From: Amanda Scholes on behalf of Planning.Responses
Sent: 07 January 2021 11:07
To: Planning Scanning
Subject: FW: Pevensey Road, BR/277/20/DOC

Please upload the below to the above application; Drainage Engineers comments.

From: Laura Gibbons <laura.gibbons@adur-worthing.gov.uk>
Sent: 05 January 2021 08:39
To: Elvin Gomery [REDACTED]
Cc: Stuart Bone [REDACTED]; Maria Tomalova <Maria.Tomalova@arun.gov.uk>
Subject: Re: Pevensey Road

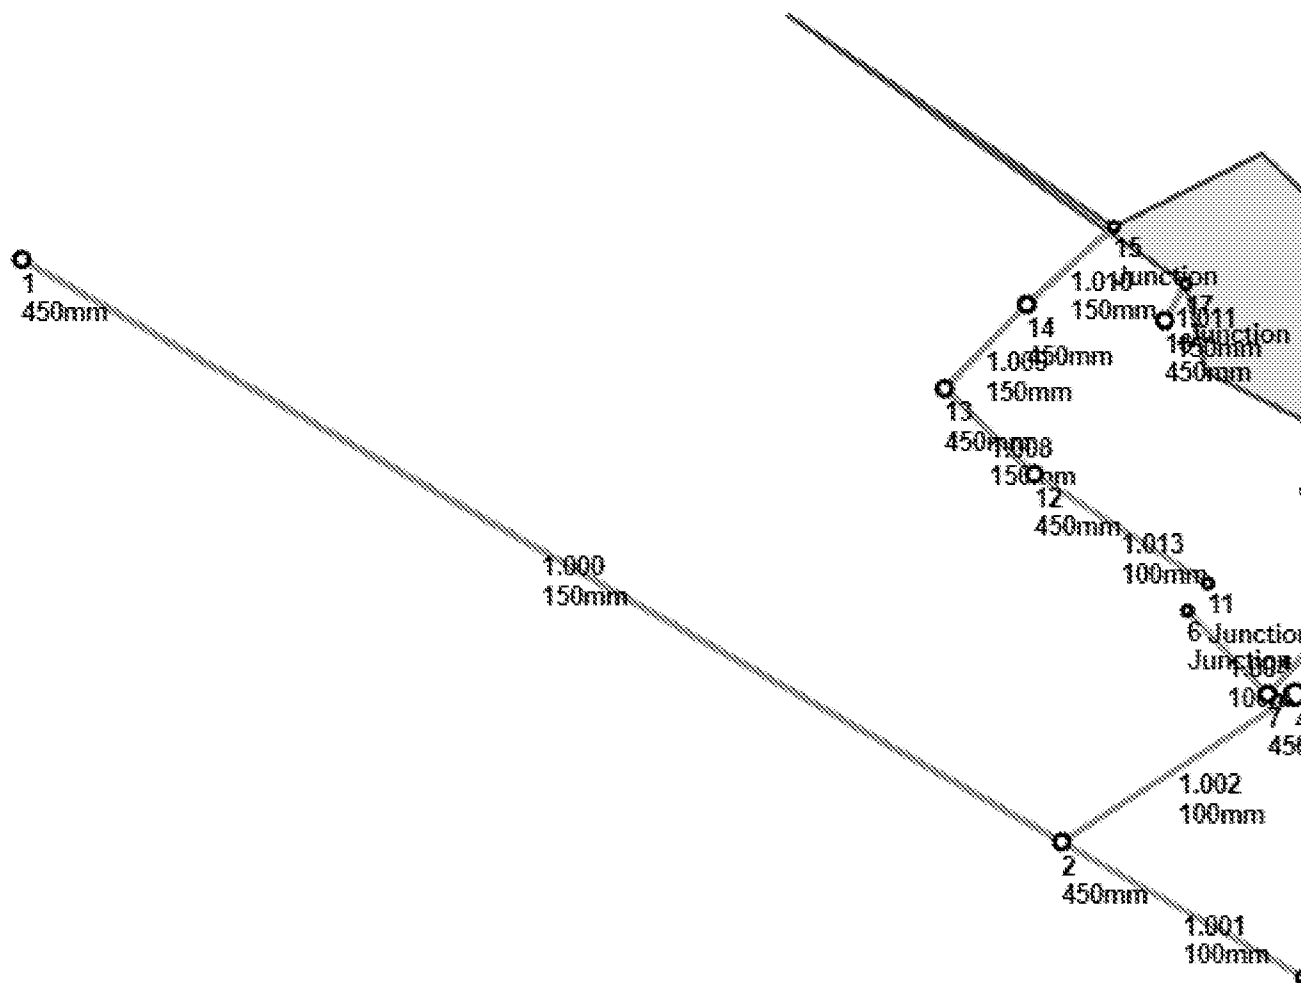
1. FEH rainfall or a Cv of 1 must be applied to calculations. Adjusted for a cv = 1.0
2. Nodes and pipe numbers should be labelled on plan to correspond with the modelled network to facilitate review. The flow file would also help my review, if possible please include this in your revised package of information. I have included the model sketch below and enclosed my FLOW file.

1. FEH rainfall or a Cv of 1 must be applied to calculations.
2. Nodes and pipe numbers should be labelled on plan to correspond with the modelled network to facilitate review. The flow file would also help my review, if possible please include this in your revised package of information.

1. FEH rainfall or a Cv of 1 must be applied to calculations. *Adjusted for a cv = 1.0 okay*
2. Nodes and pipe numbers should be labelled on plan to correspond with the modelled network to facilitate review. The flow file would also help my review, if possible please include this in your revised package of information. I have included the model sketch below and enclosed my FLOW file. *okay*.
